Access Compliance Report

Public Rights-of-Way

(Curb Ramps)

Intersection ID: N/A	Main Street: WOODLAWN_ST	Cross Street: N/A	Location: SE
ADA ID: BEBA0A6704EA	Ramp Type: Directional1	Initial Pass/Fail: Fail	Overall Compliance: No
Severity Score: 1.25			
Codes/Mitigation Info/Possible Solution		Field Measurements/Component Compliance

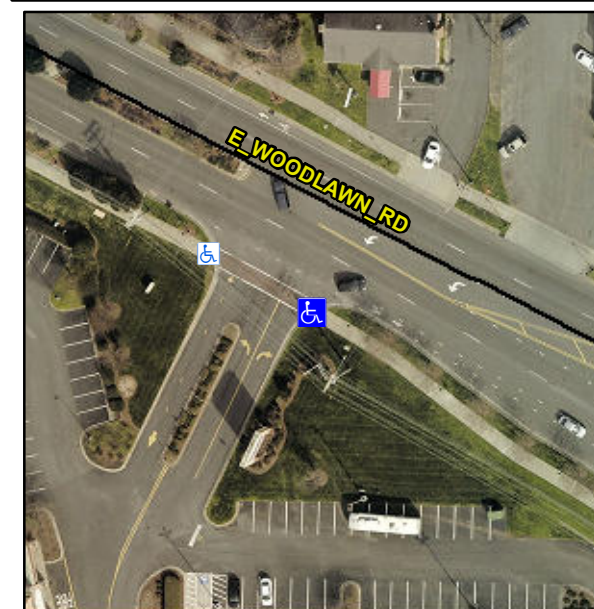
R304.5.3

Compliance	Description	Data	Compliance	Description	Data
N/A	Ramp Length (in)	67.0	N/A	Grade Break?	N/A
Yes	Ramp Width (in)	48.0	N/A	Grade Break Slope (%)	0.0
Yes	Ramp Slope (%)	0.7	N/A	Grade Break XSlope (%)	0.0
No	Ramp XSlope (%)	2.5			
N/A	Flare Type LT	N/A	N/A	Flare Type RT	N/A
N/A	Flare Slope LT (%)	N/A	N/A	Flare Slope RT (%)	0.0
N/A	Flare Traversable LT?	N/A	N/A	Flare Traversable RT?	N/A
N/A	Landing Length (in)	0.0	N/A	DWS Provided?	N/A
N/A	Landing Width (in)	0.0	N/A	DWS Contrast?	N/A
N/A	Landing Slope (%)	0.0	N/A	DWS Length (in)	N/A
N/A	Landing X Slope (%)	0.0	N/A	DWS Full Width?	N/A
N/A	Landing Curb? (Y/N)	N/A	N/A	DWS Offset LT (in)	N/A
N/A	Shared Landing?	N/A	N/A	DWS Offset RT (in)	N/A
N/A	Gutter Ponding?	0.0	N/A	Gutter Slope (%)	N/A
N/A	Gutter Lip Ht (in)	0.0	N/A	Gutter X Slope (%)	N/A
N/A	Painted X Walk1?	Yes		Road Slope (%)	1.5
	X Walk 1 Direction	To W		Road X Slope (%)	1.7
	X Walk 1 Width (in)	93.0		Clear Space?	N/A

Remove & Replace Entire Ramp.
